LIVINGSTON
(LLO)

ELEVATION

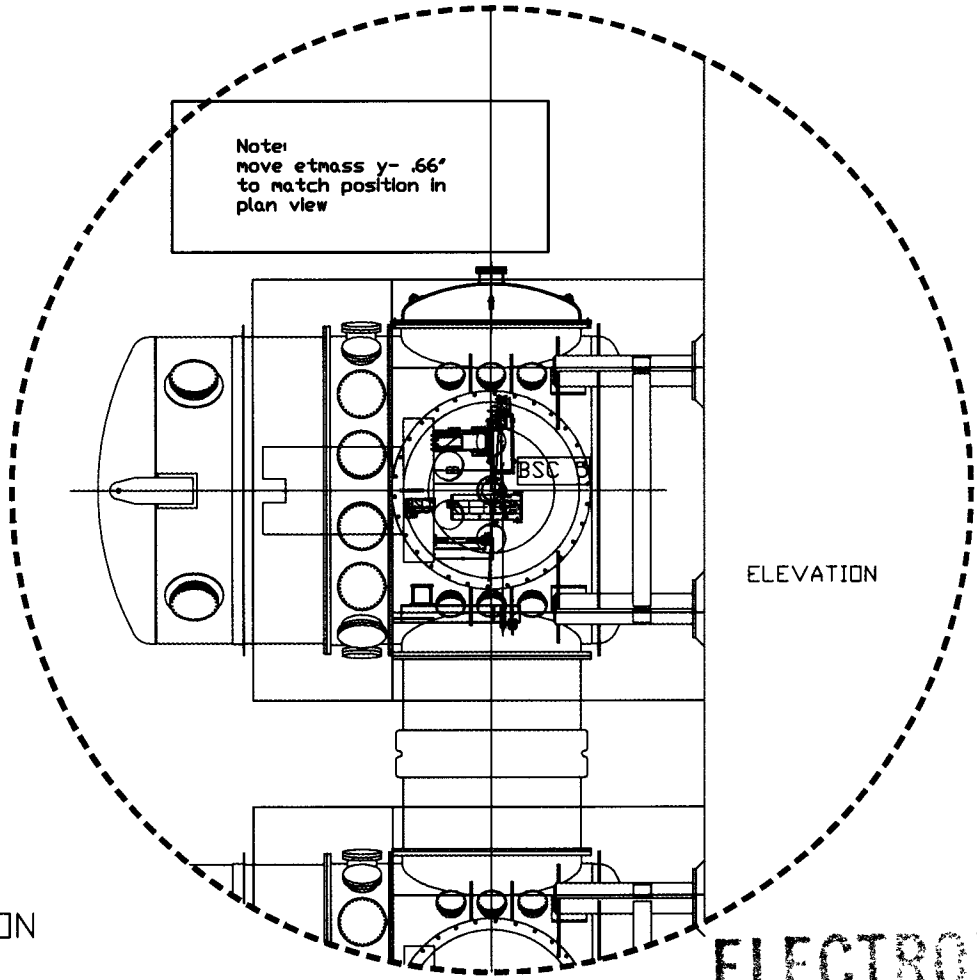
Note:
move etnass y- .66"
to match position in
plan view
